**FINAL  
ENVIRONMENTAL IMPACT REPORT**

**SCHMIDT ROCK QUARRY  
VENTURA COUNTY**

County of Ventura  
Planning Commission  
Hearing  
Case No. PL18-0136  
Exhibit 7 - Final 1995 EIR  
With 2012 Addendum

**DRAFT  
ENVIRONMENTAL IMPACT REPORT  
SCHMIDT ROCK QUARRY  
CUP - 3489 (MOD 2)**

# RECLAMATION PLAN - CROSS SECTIONS AND DETAIL VIEWS

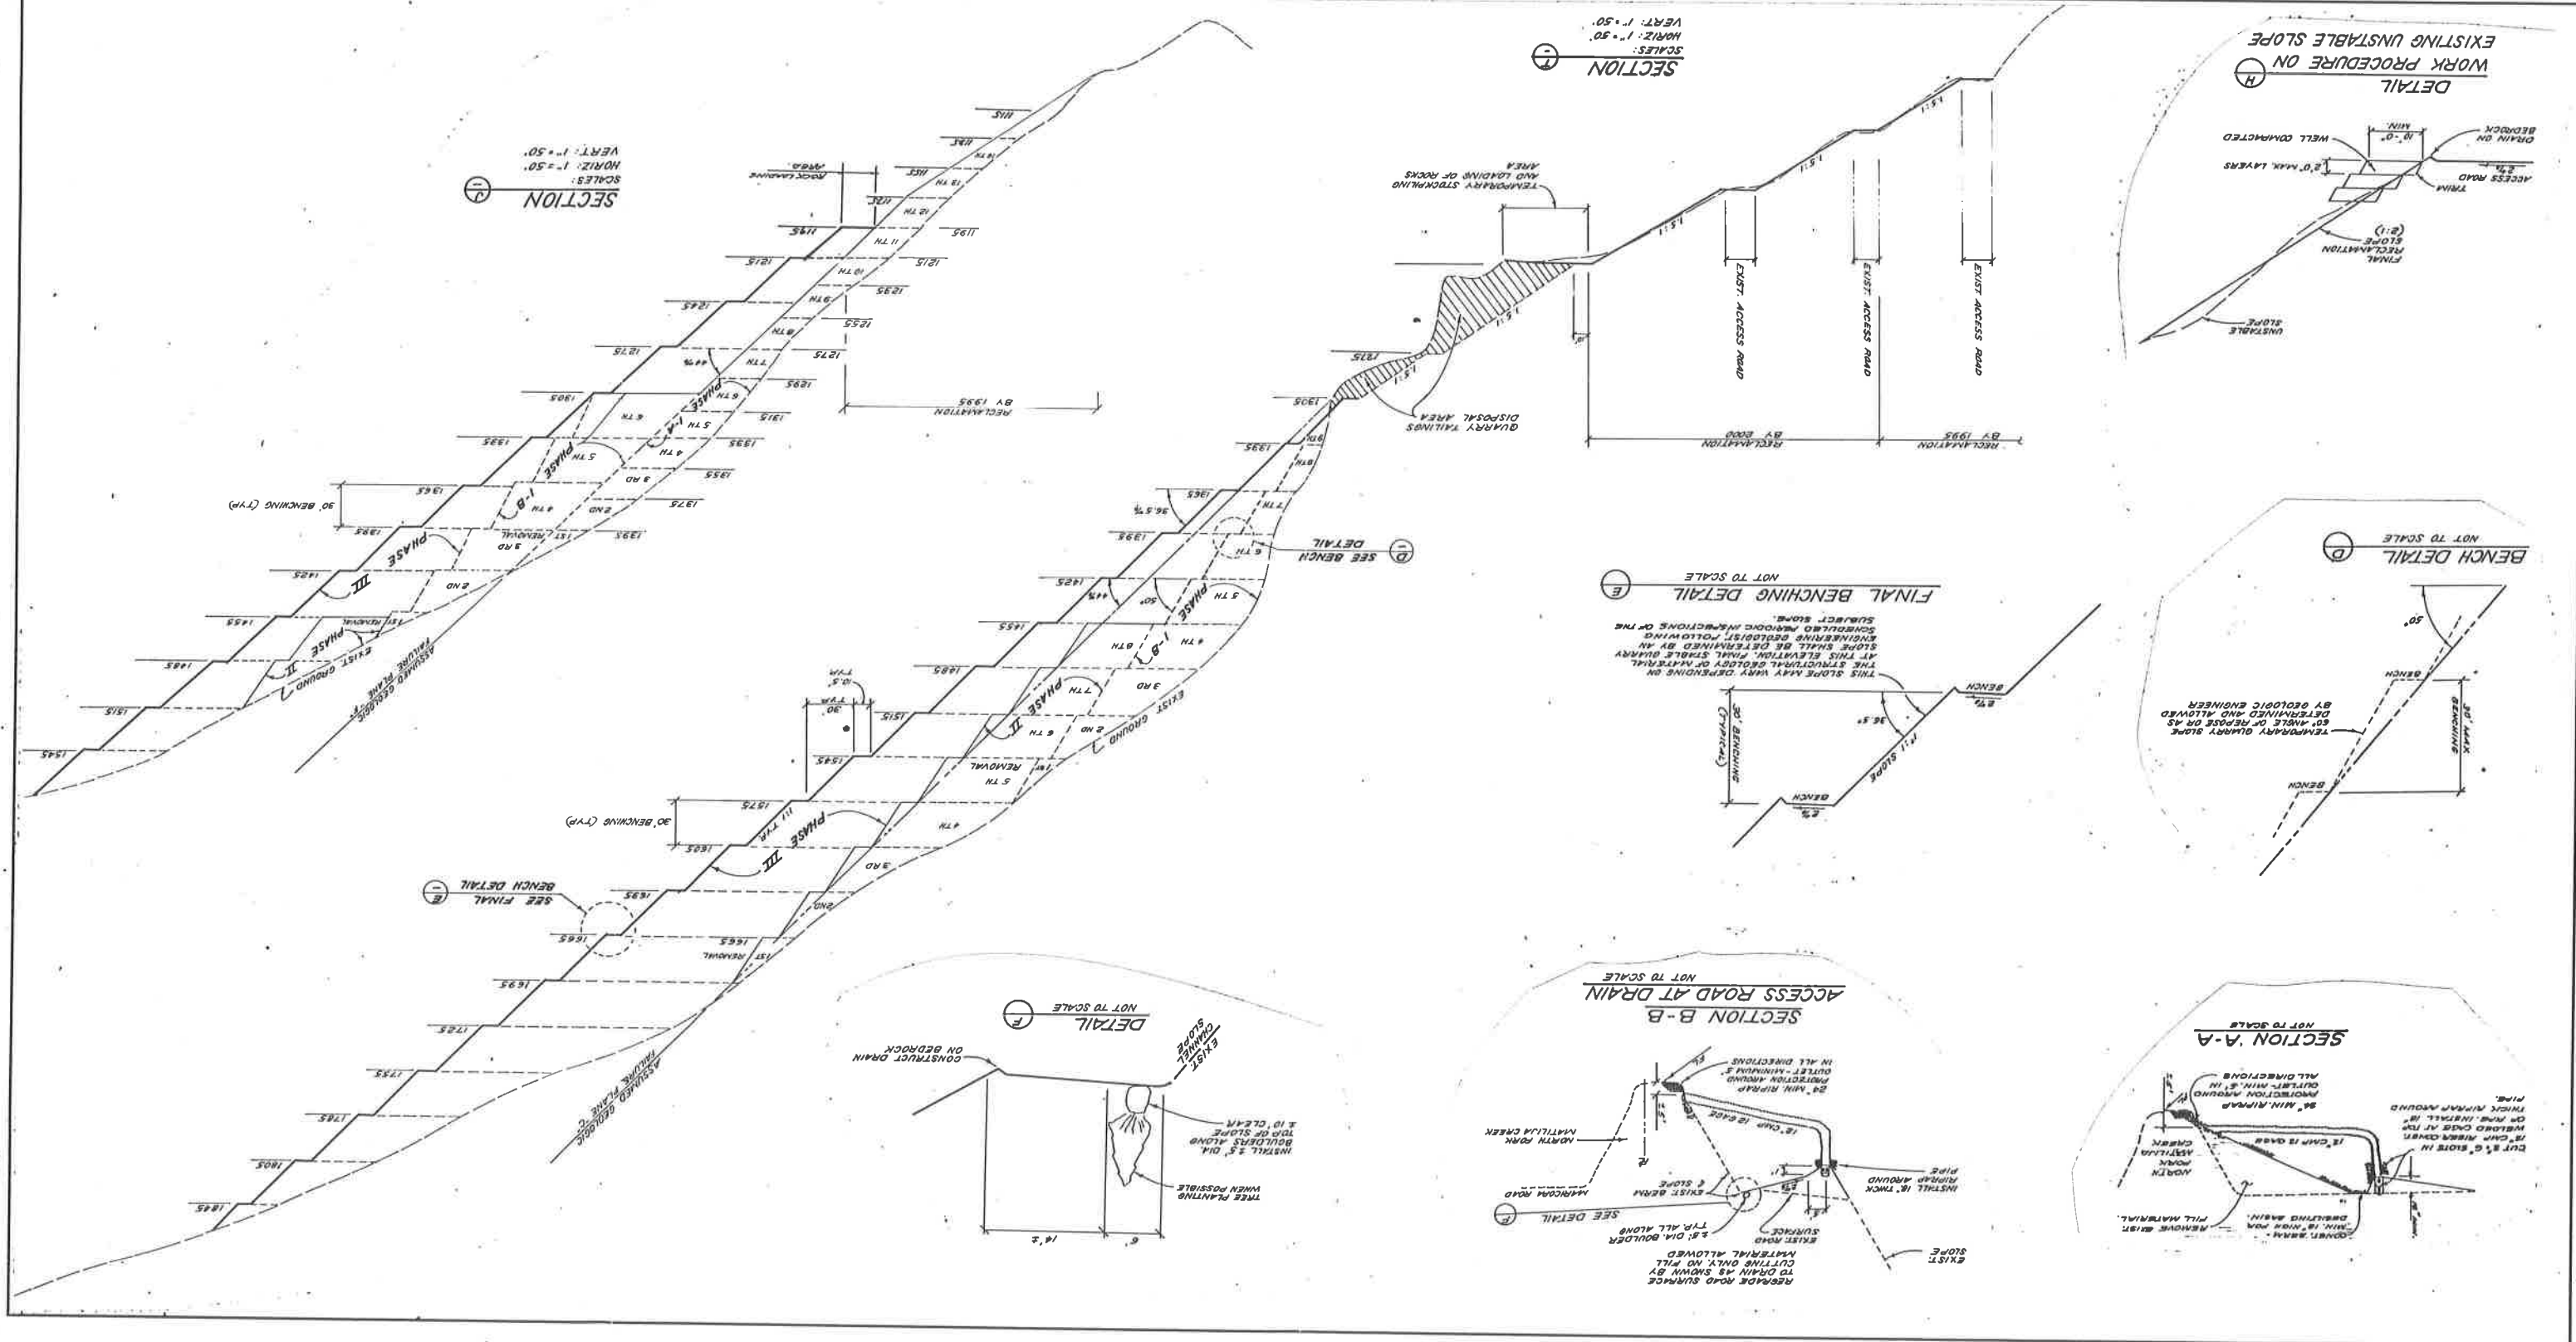
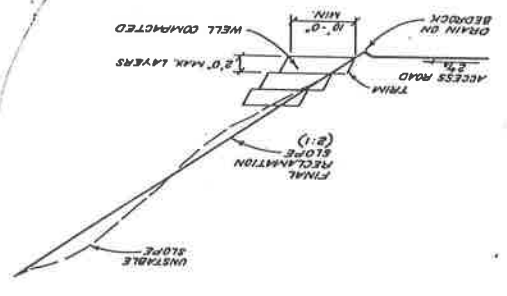
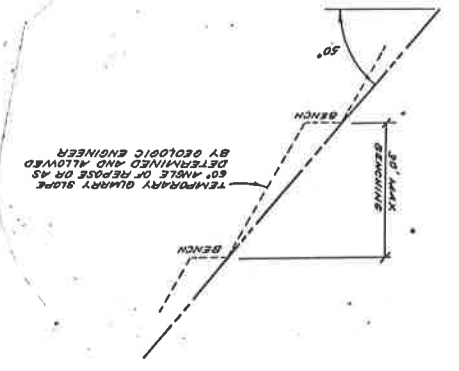
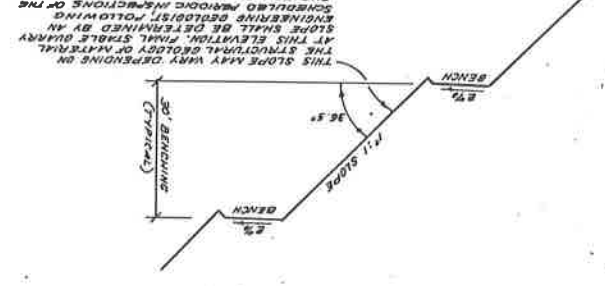
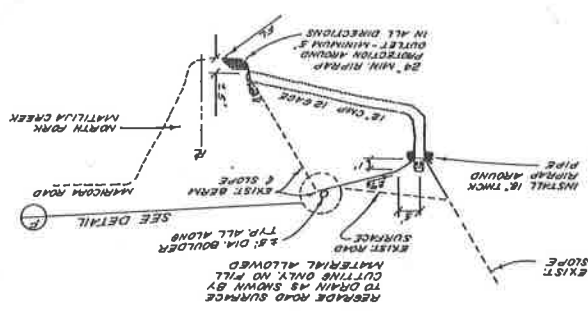
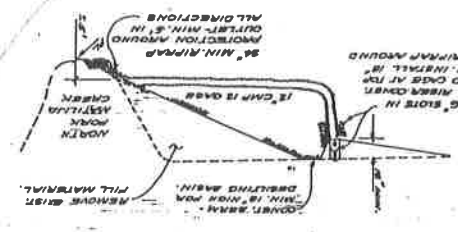
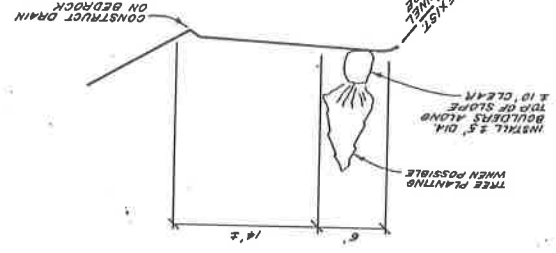
Reclamation Notes Item 2.0 of Exhibit 8A has been revised to read:

ALL EXISTING SLOPES WHERE QUARRY TAILINGS (UNCERTIFIED FILL) WERE USED SHALL BE INSPECTED BY THE ENGINEERING GEOLOGIST TO VERIFY ITS SLOPE STABILITY. ~~IF FOUND UNSTABLE, SAID SLOPE SHALL BE REWORKED USING CERTIFIED FILL TO A STABLE 1:1 SLOPE.~~ FINAL FILL SLOPES MAY BE AT A 1.5H:1V GRADIENT ONLY IF ENGINEERING SLOPE STABILITY ANALYSIS DEMONSTRATES THAT THEY WILL BE STABLE AT THIS GRADIENT AND SUCCESSFULLY REVEGETATED. OTHERWISE FINAL FILL SLOPES WILL BE AT A 2H:1V GRADIENT. SEE DETAIL (H). PLANT TREES OR NATIVE SHRUBS WHERE SHOWN ON RECLAMATION PLAN, SHEET 2 OF 4.
